R09PF

**SUBJECT: RECALL R09PF INSUFFICIENT TORQUE ON STEERING
GEAR MOUNTING FASTENERS**

Steering Gear Bolts

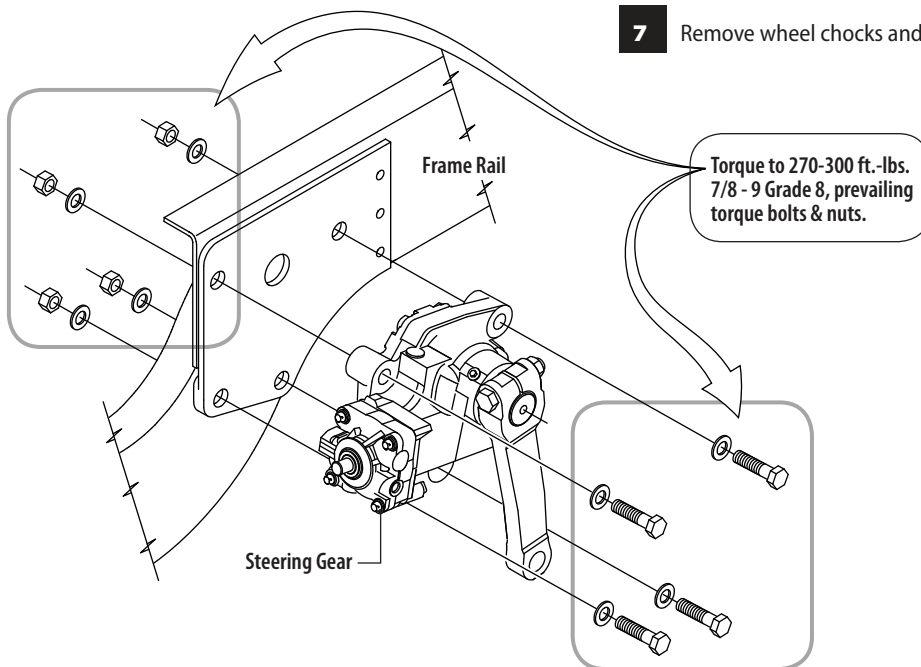
Steering gear mounting bolts may have been incorrectly torqued at installation.

Inspect and re-torque the four bolts that attach the steering gear to the frame rail.

3 Inspect the bolts and nuts for any damage. If damaged, replace, **DO NOT** re-torque. If damage exist and new fasteners are required, contact:

4 If no damage exist, re-torque the fasteners to 270-300 ft. lbs. See diagram below.
